DESCRIPTIVE REPORT

Type of Survey Wire Drag
Field No. RH-40-1-73
Office No. H-9374 WD

State Mississippi & Alabama
General Locality Gulf of Mexico
Locality Mobile Bay Entrance

OFFICE OF MARINE SURVEYS AND MAPS
HYDROGRAPHIC SURVEYS DIVISION
LIMITED HYDROGRAPHIC SURVEY REVIEW

CHART 87252

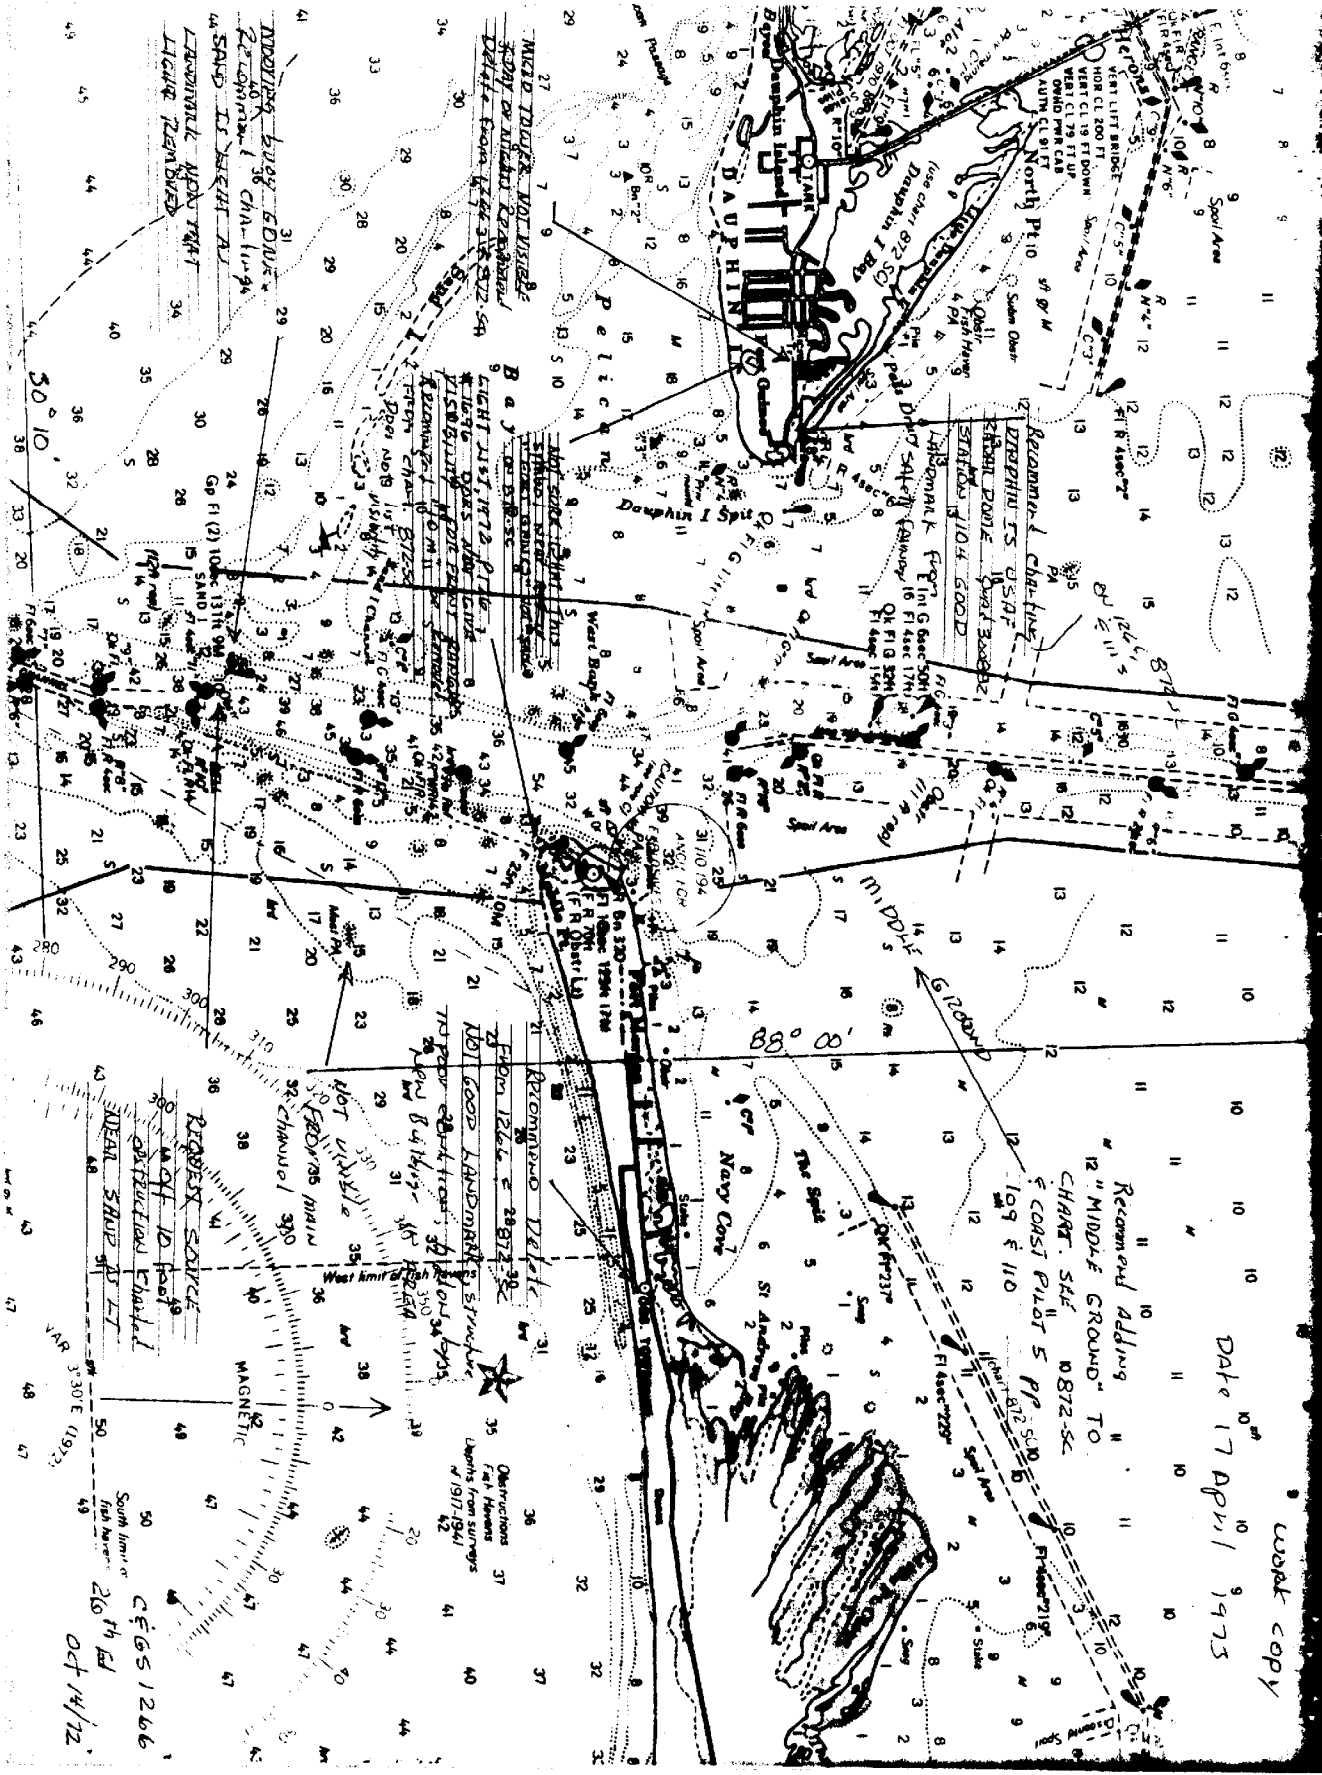
CHART CORRECTION , CHART 872-SC

No. 1. TANK in 4 feet of water at 1830Z MAY 4,1973 protruding
16 inches above the water surface.

No. 2. PILE in 6 feet of water at 1815Z MAY 4,1973 protruding
12 inches above the water surface.
